## **Addendum No. 2**

### **D'ANDREA #3 PUMP STATION**

**PWP Bid No.: WA-2017-072**  
**TMWA Capital Project No.: 13-0020**  
**February 3, 2017**

**D'ANDREA 3 PUMP STATION  
PUMP STATION PIPING PLAN**

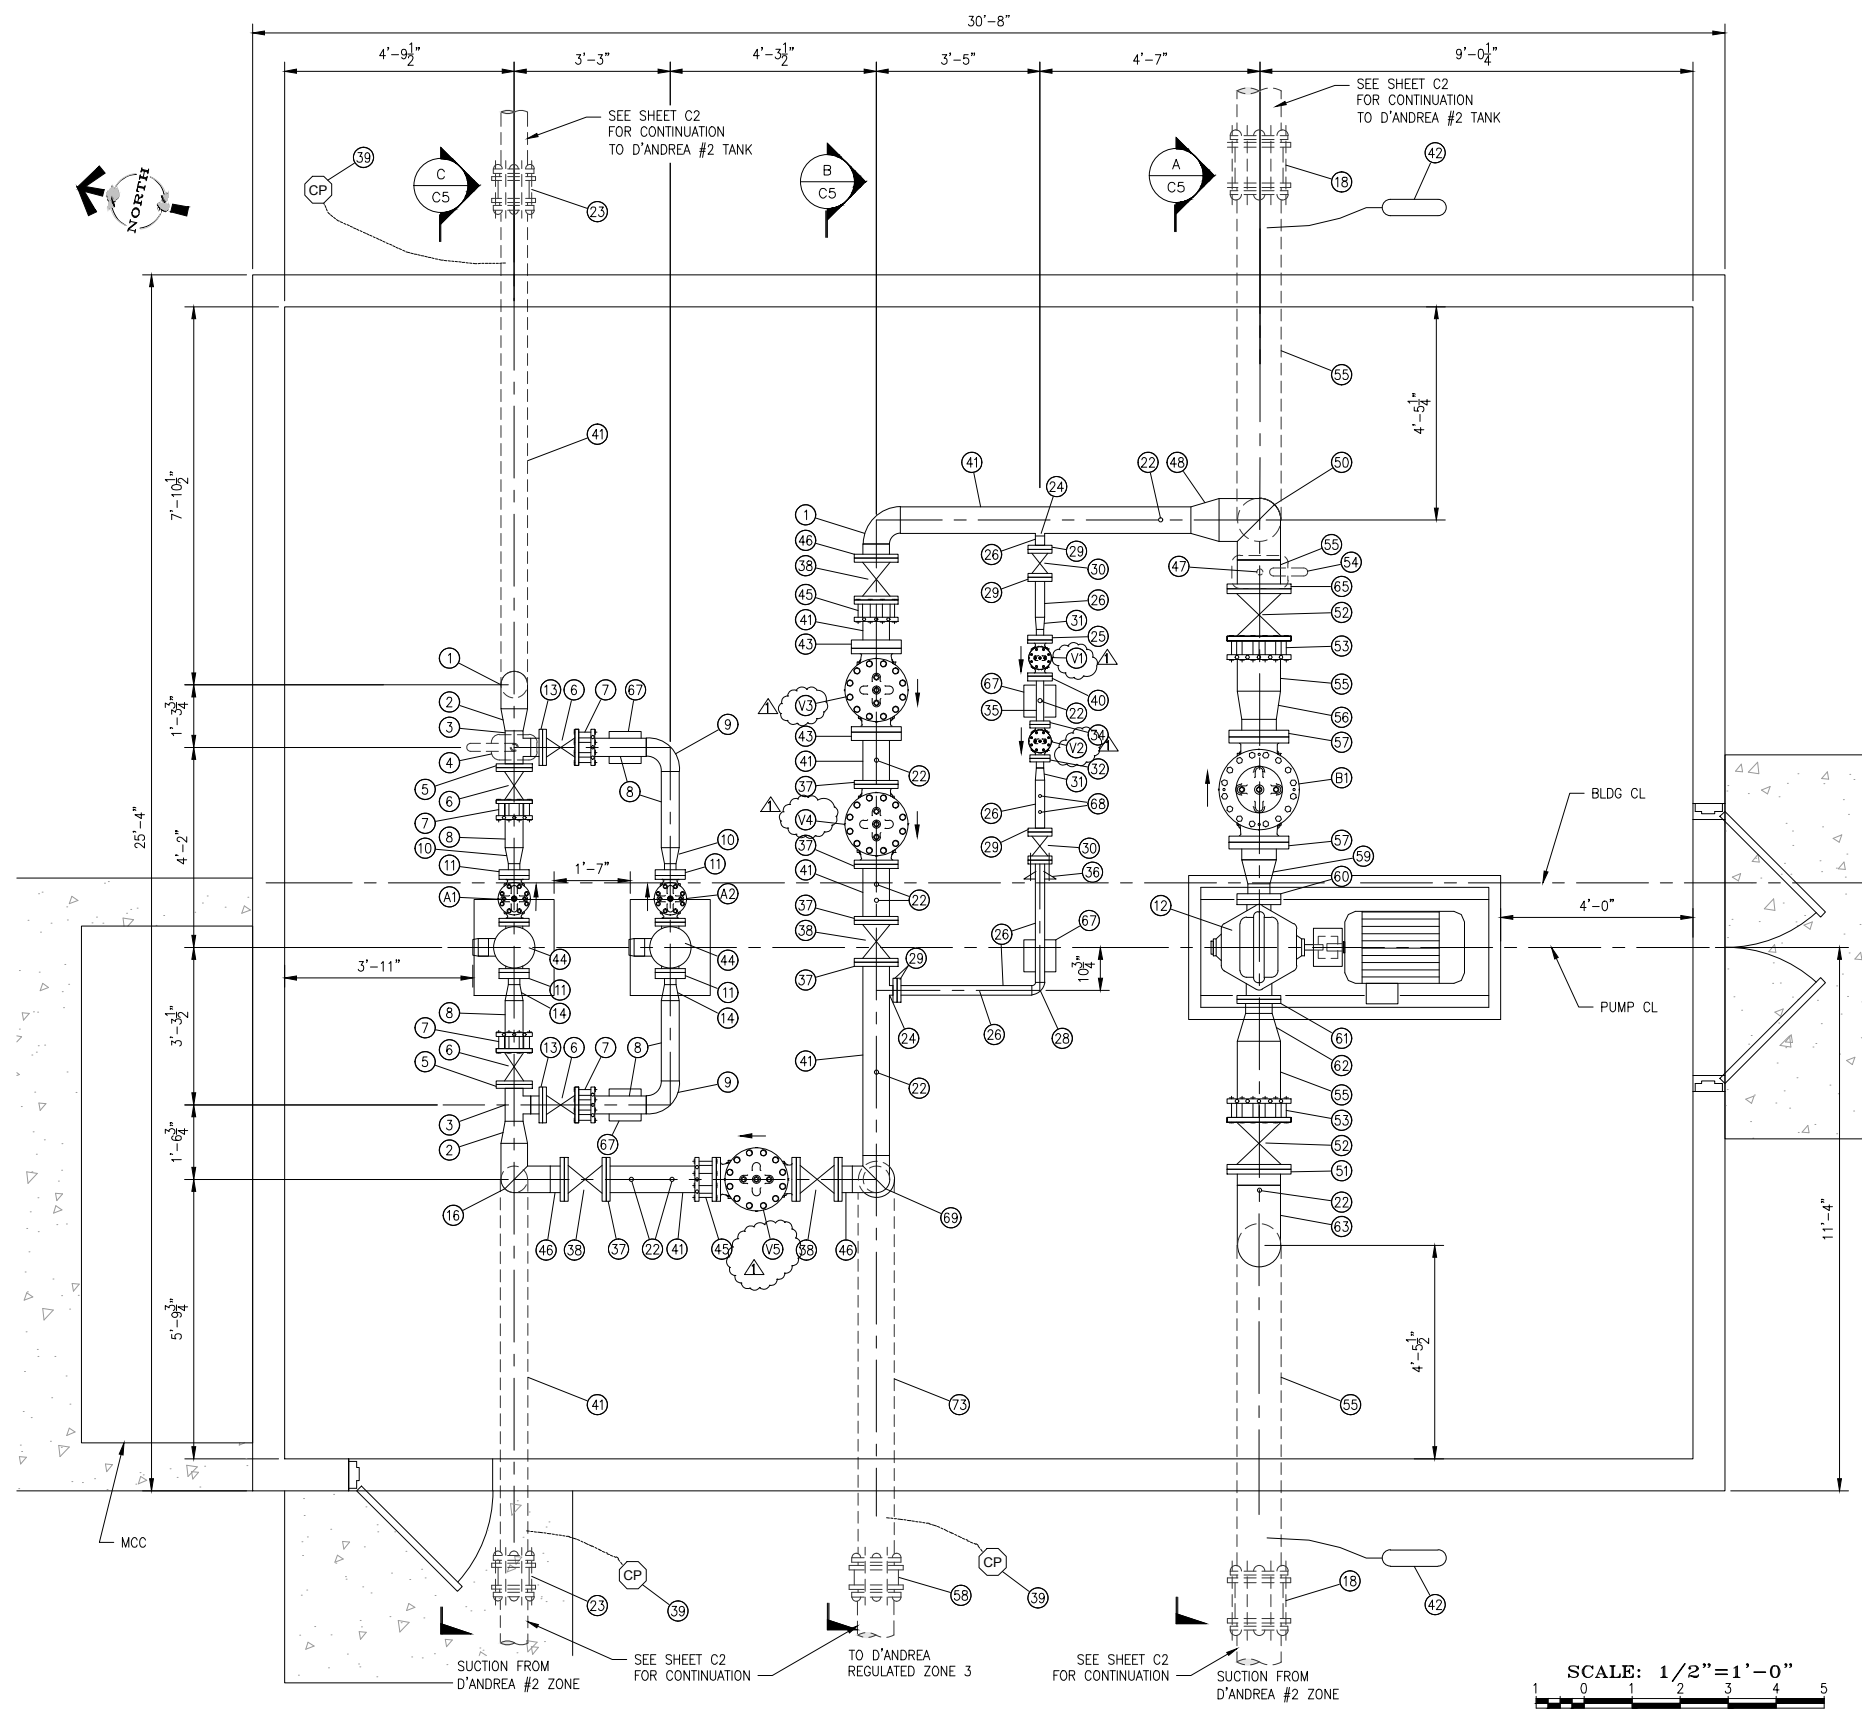
**Question No. 1:** I am doing my take off of the materials I have noticed some irregularities in the valve schedule as well as called out pressure class mating flanges. On C5 the PRV valve list does not contain V8 which is shown on Dwg. C4 the list also shows V3 as a 6" valve, but it appears on an 1-1/2" line on Dwg C4.

**Question No. 2:** On C5 the PRV valve list V2 is listed as a 150# flanged valve yet the Dwg C4 the materials list shows items #25 and #40 as 300# mating flanges.

**Question No. 3:** On C5 the PRV valve list V4 is listed as a 150# flanged valve yet the Dwg C4 the materials list shows items #43 and #43 as 300# mating flanges.

**Question No. 4:** Please clarify these issues, and provide V8 downstream PSI setting and that it is a 150# class flanged valve.

**Response to Question No. 1:** The valve callouts on Sheet C4 have been corrected to match the valve schedule table on sheet C5. The revised sheet C4 is included as part of this addendum.

Replace sheet C4 of the Contract Drawings with Sheet C4 attached. The valve IDs have been corrected to match the table on sheet C5.
